## **ADDENDUM**

SUBJECT: Addendum No. 1 – ITB # 6013  
Access Road from James H. Quillen V.A. Medical Hospital to W. Market  
Street (S.R. 34/U.S. 11E), TDOT PIN 102618.00

DATE: 02/12/2016

**PRESENT LAYOUT**  
STA. 101+00 TO STA. 111+00  
SCALE: 1"=50'

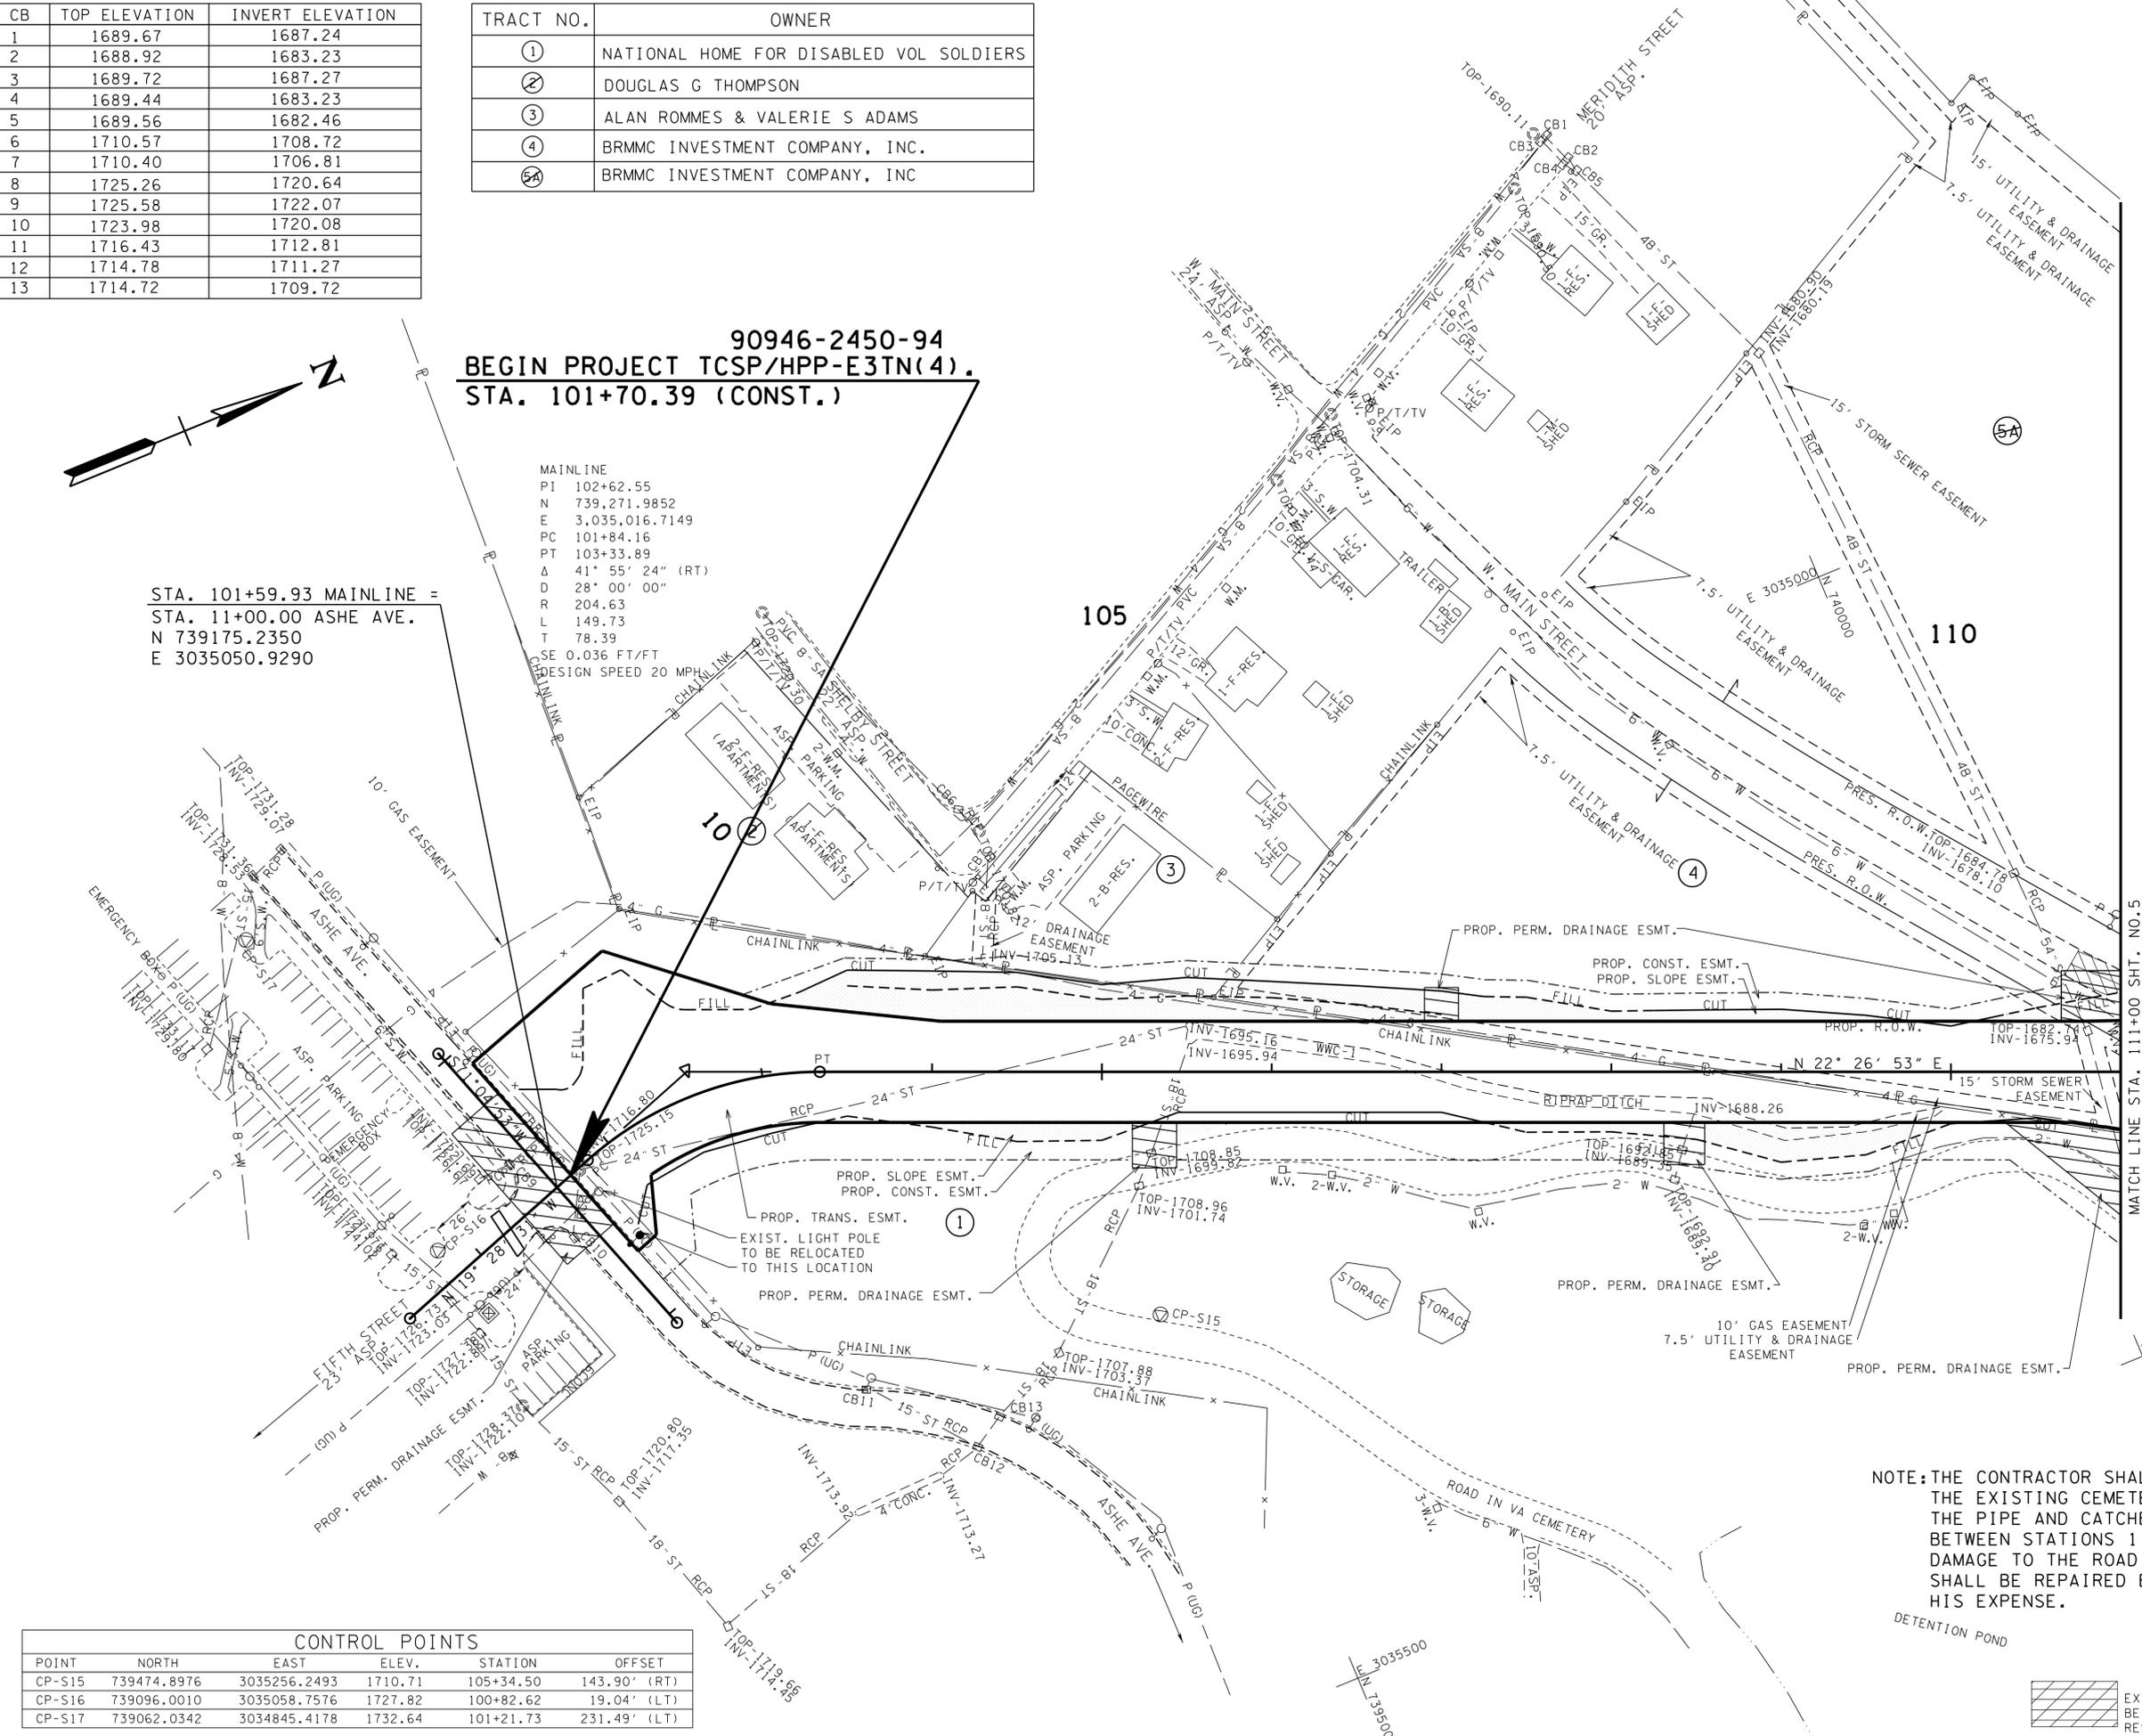
2. A light pole near the start of the project (approximately STA101+77) needs to be relocated outside of the new road. In order to relocate the pole, 2 new bid items have been added to the bid form and Sheet 2 and Sheet 4 of the plans have been revised. **The attached revised bid form (noted and dated in the footer of the bid form) will delete and replace the original bid form for this project.** The contractor shall submit the entire bound set of contract documents with the revised bid form. **The attached revised Sheet 2 will delete and replace the original Sheet 2 in the plans. The attached revised Sheet 4 will delete and replace the original Sheet 4 in the plans.**

V.A. ACCESS RD. WASHINGTON CO.  
90946-2450-94 (CONST.)  
REV. 2-8-16: Added Note Regarding  
Light Pole to be Relocated.
